**From:** Geoff Engler <gengler@s-e-b.com>  
**Sent:** Wednesday, July 27, 2022 1:03 PM  
**To:** smellish11@comcast.net; Sue Brown <browns@manchester.ma.us>  
**Cc:** George Pucci <GPucci@k-plaw.com>; Jay Talerman <jay@mtclawyers.com>; Carlton Quinn <cquinn@allenmajor.com>; Stacy Minihane <sminihane@bealsandthomas.com>; Andrew Gorman <agorman@bealsandthomas.com>; Matthew Cote <mcote@bealsandthomas.com>  
**Subject:** Two quick notes: SLV School Street

PROJECT:  
THE SANCTUARY  
SCHOOL STREET  
MANCHESTER-BY-THE-SEA, MA

DRAWING TITLE: IMPERVIOUS BARRIER/ INFILTRATION SYSTEM CROSS-SECTIONS EXHIBIT SHEET No. C-203

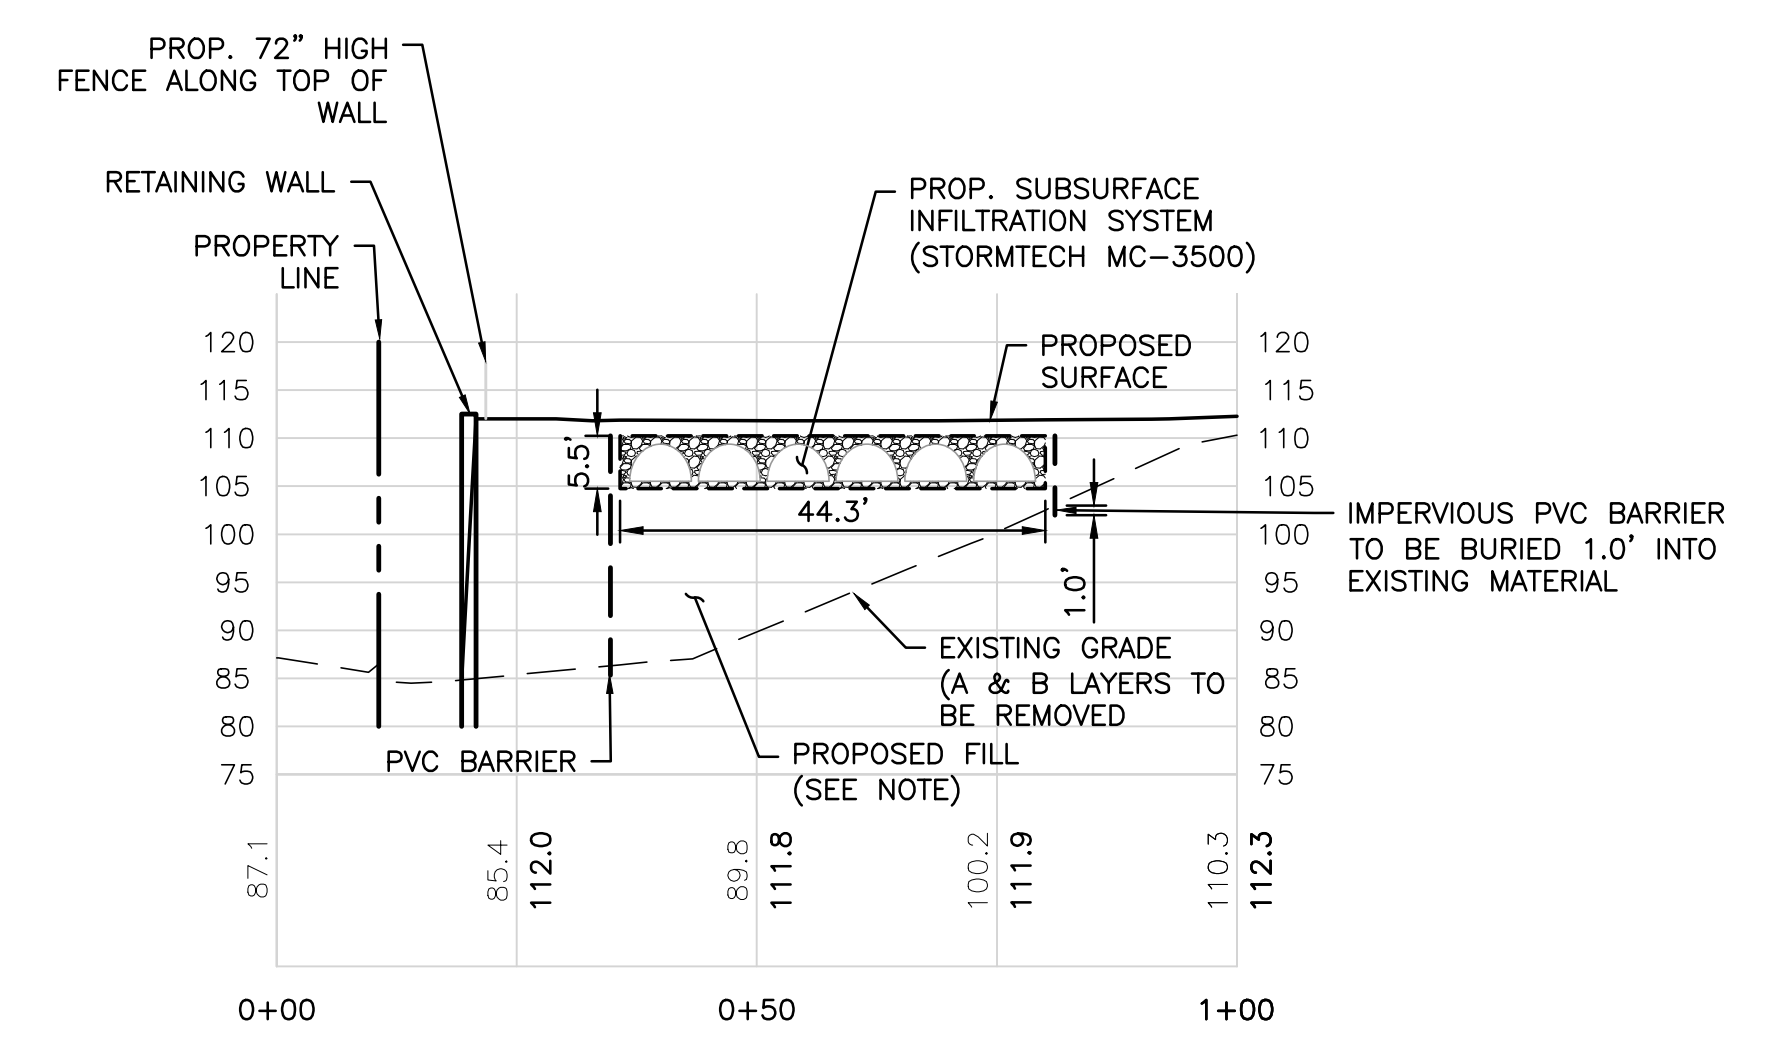
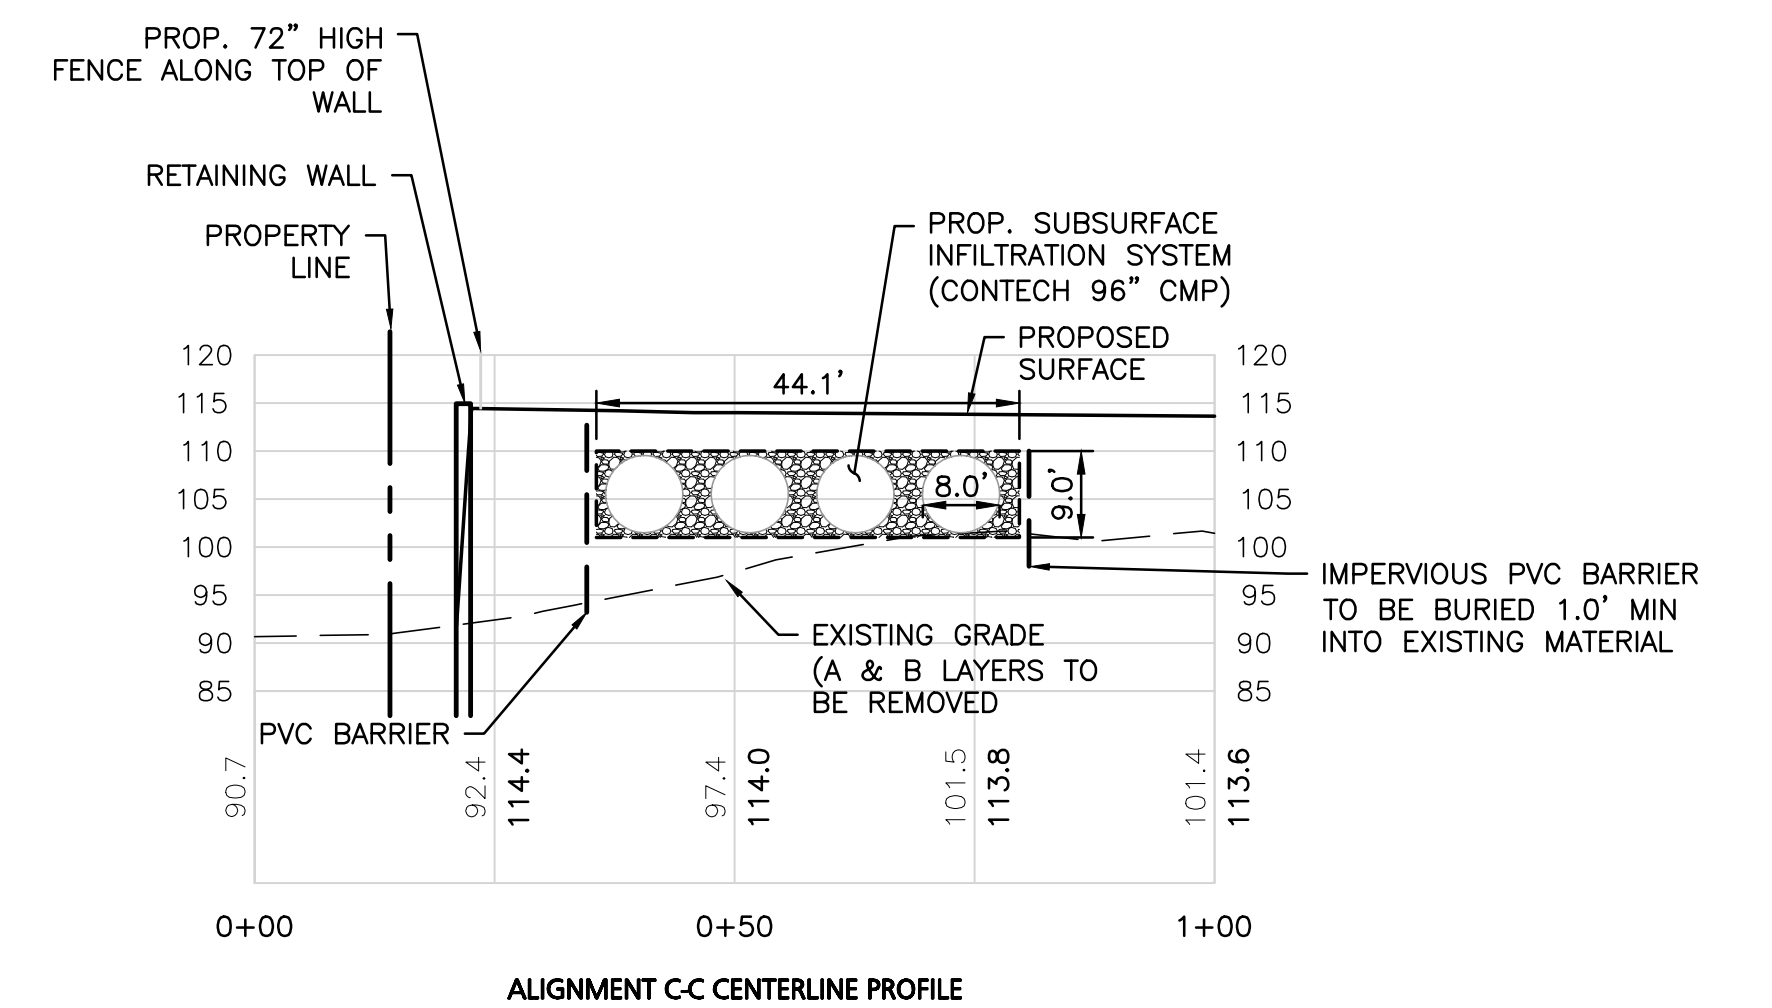
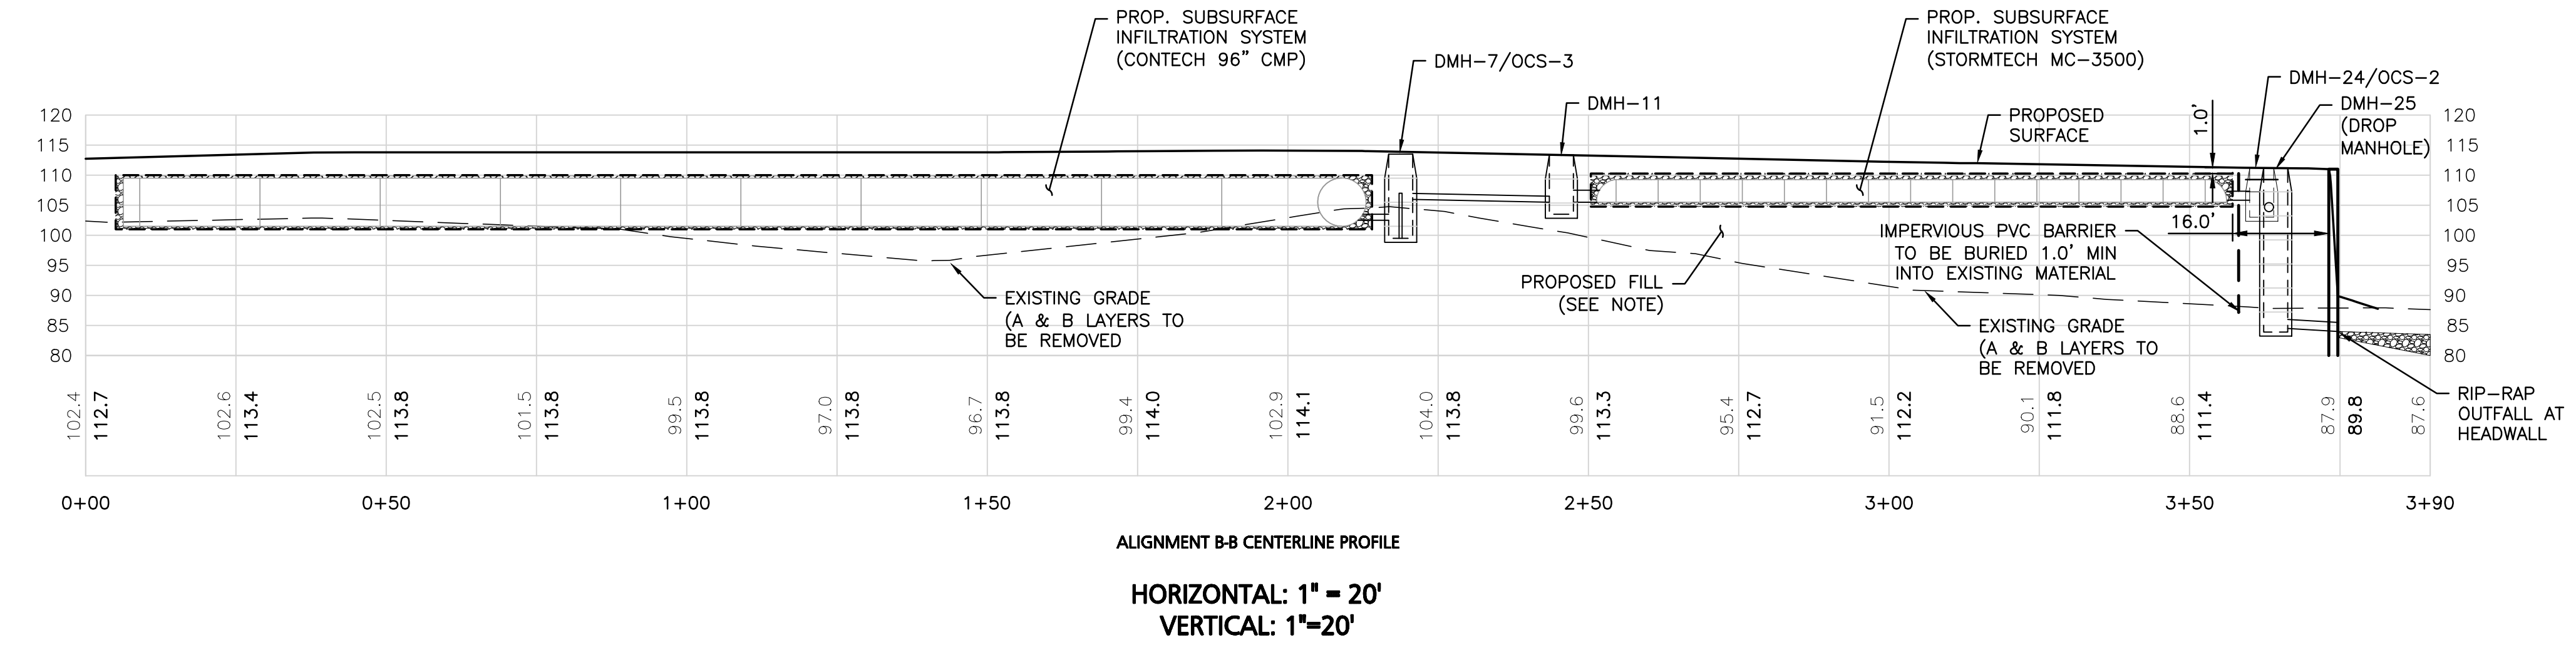
*– The design of the southern retaining wall remains pending. Proximity of the retaining wall to the infiltration basin may result in lateral instead of vertical movement of infiltrated stormwater, which would be more likely to affect vernal pool hydrology. Specifically, that stormwater could discharge tributary to the vernal pools in lieu of recharging groundwater.*

*– Hydrogeologic information for the path of flow from Underground Infiltration System-1 and Underground Infiltration System-2 has not been specifically determined. The Applicant should confirm that subsurface conditions throughout the systems (i.e. soil texture, presence of restrictive layers, and/or refusal) will allow vertical flow of infiltrated water vs. horizontal flow.*

We thought it would helpful for the record if we submitted a response to the two comments I included below which were extracted from the latest B&T report. The attached cross section was prepared in part to demonstrate how we plan to address the B&T concerns.
